THIRD PARTY OBSERVATION – SID APPLICATION CASE REF. 324162

Permission for 220kV Substation and 220kV underground electricity cabling connecting to the existing Cashla 220kV substation

Case Reference: SID Application VA07.324164

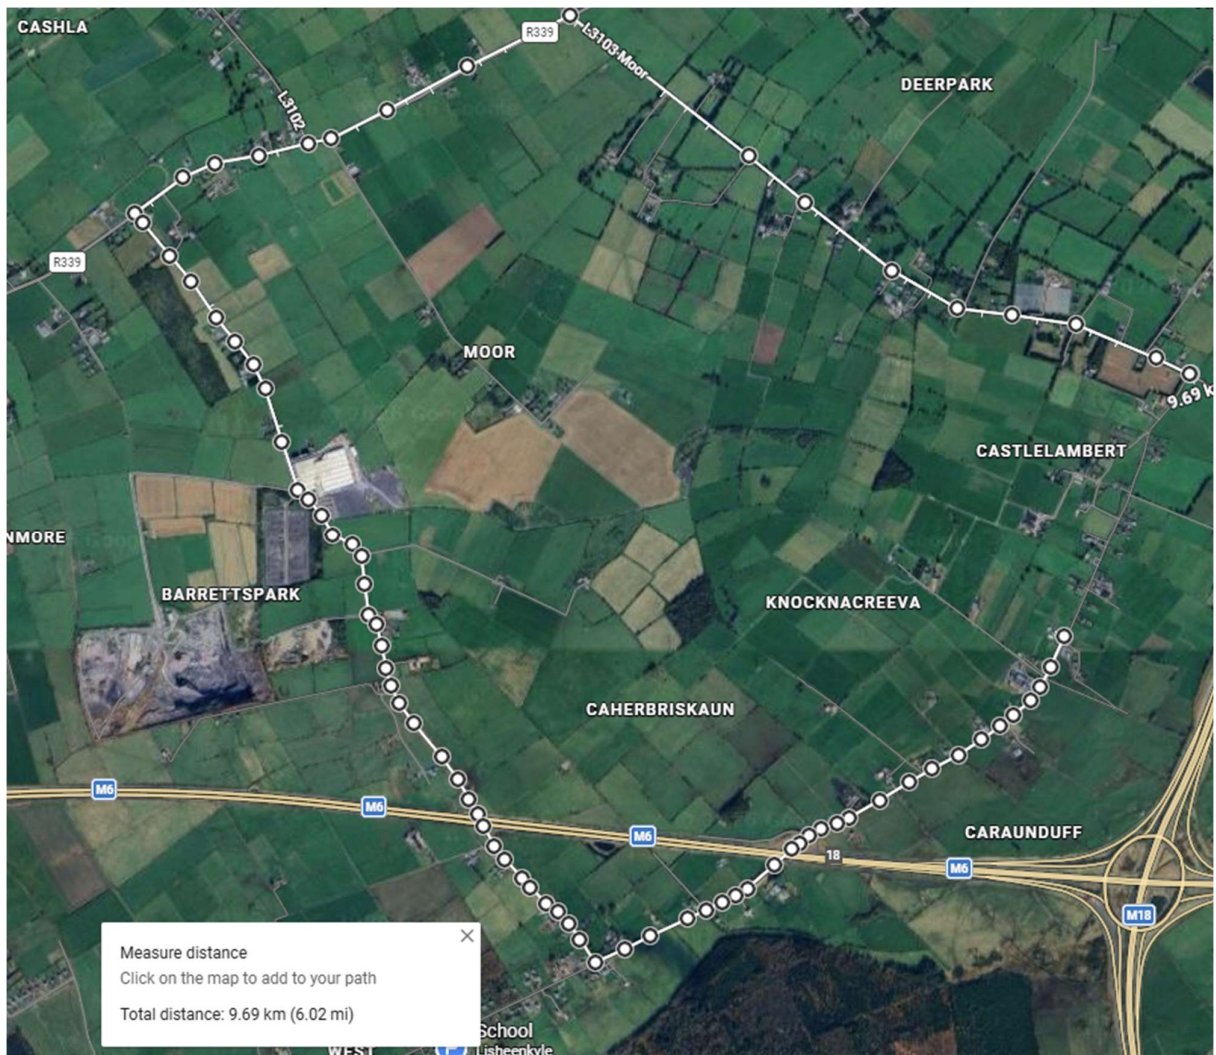
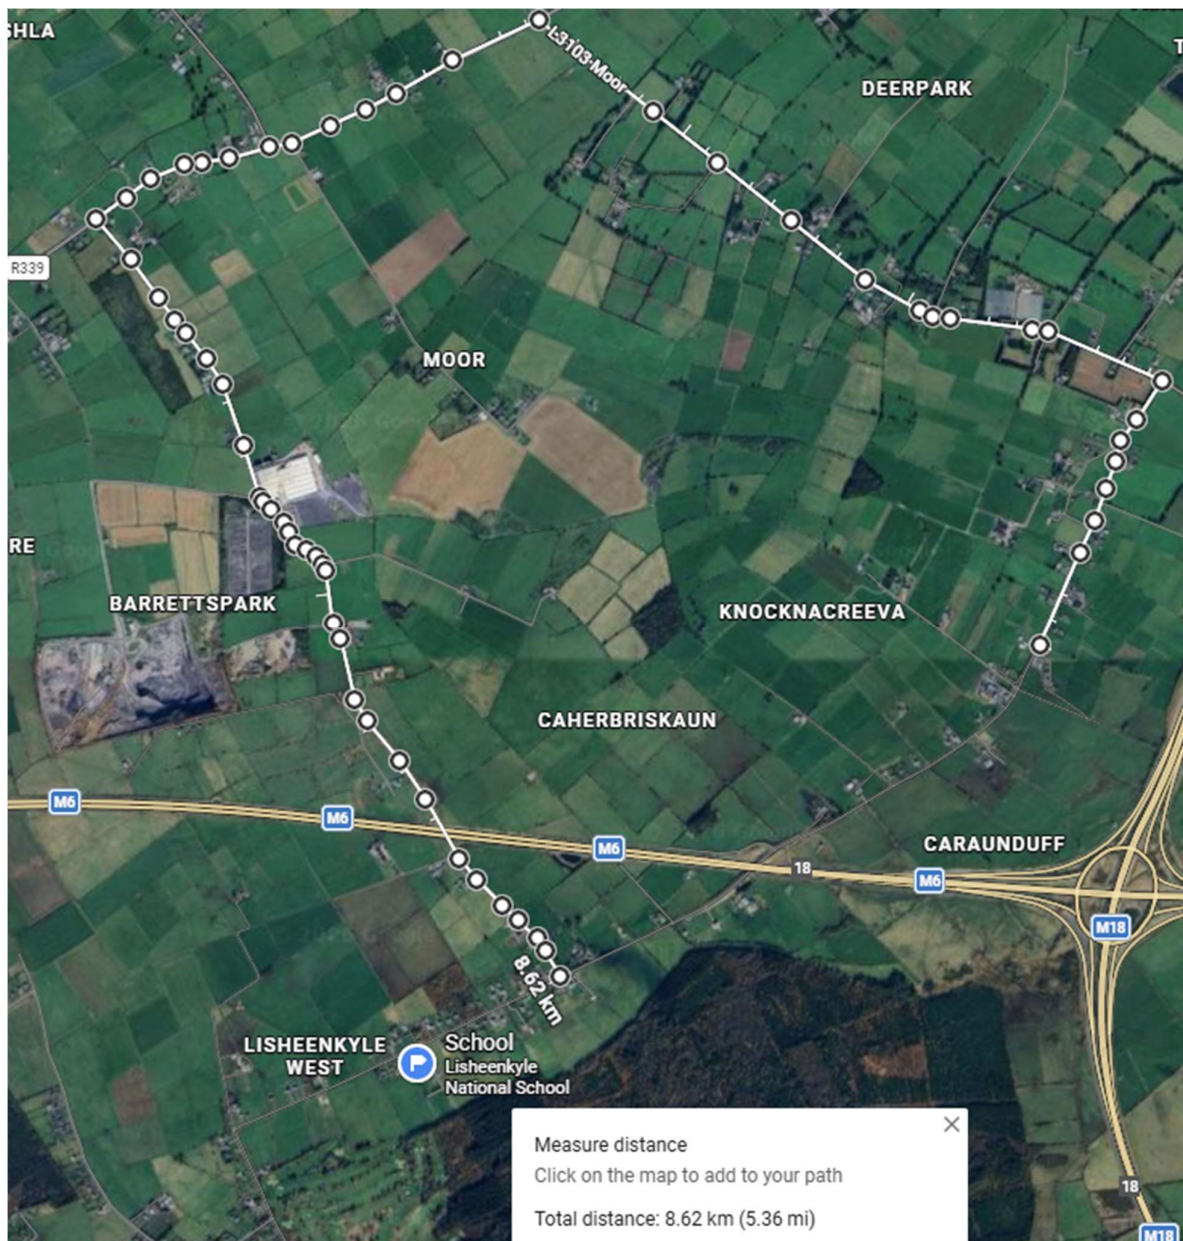
I would say that this is not accurate, or detailed enough, it is too simplified. When we have to travel via L7109 onto R339 to get access back onto L3103, our access road to Athenry town, it will add an additional 8.69km to my journey, nearly double what the applicant is implying.

This is why I am saying it is too simplified, the proposed diversion, is only relative to the location someone is living in.

Image above shows the diversion proposed when the road is closed, when I need to access Athenry town or collect my children from secondary school or sport or music activities.

Equally if I am diverted the opposite direction, when road is closed and I need to drop of or collect my kids from Lisheenkyle school, it will be an extra 6.62km to our journey, 13.24km round trip twice daily.
